Applicant: Rider University (Alumni Gymnasium), 2083 Lawrence Road

Appl. No.: SP-5/21

SUBJECT: Major Site Plan – Preliminary & Final Approval with Variance Application No. SP-5/21  
**Rider University (Alumni Gymnasium)**, 2083 Lawrence Road  
Tax Map Pages 28.02 – 28.04, Block 2801, Lot 24

**Re:** **Rider University**  
**Preliminary and Final Major Site Plan with Sign Variances**  
Block 2801 Lot 24  
2083 Lawrenceville Road  
EGI (Education, Government & Institutions) Zoning District  
Application No. SP-5/21

FEMA Flood Map. Keep in mind this is “look back” data and does not reflect current and future rain predictions.

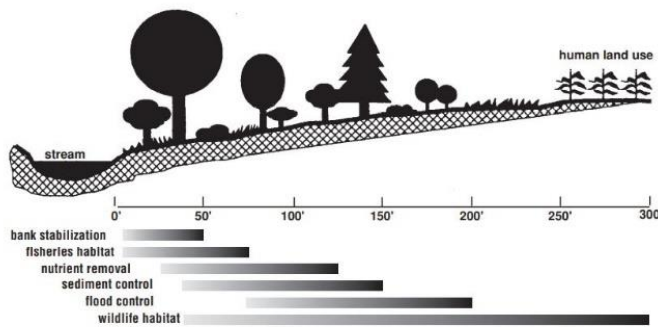
1. The visitor parking lot is up against the bank of Little Shabakunk, a major tributary that flows through Lawrence, to the Assunpink and through Trenton. Sections of the parking are in a Flood Hazard Area. Frequent flooding is causing erosion and resulting in degradation of the parking lot surface, as well as rendering the parking places closest to the stream unusable after significant rain events. Also, the parking surface is vulnerable to freeze/thaw damage given the wet soil conditions. According to the DEP, annual rainfall in New Jersey is projected to increase 7% to 11% by 2050 and will often be delivered in more intense storm events so this area will continue to flood regularly. **For these reasons, we suggest de-paving this area of the parking lot immediately adjacent to the stream, rather than the corner section indicated in the existing plans.**

2. Use the de-paved area along the stream for a Riparian Buffer, including trees and shrubs, to stabilize the stream banks, limit erosion and to filter and mitigate stormwater runoff. Trees and shrubs offer greater stabilization as well as stormwater mitigation through uptake and evapotranspiration than grasses while also mitigating thermal pollution.
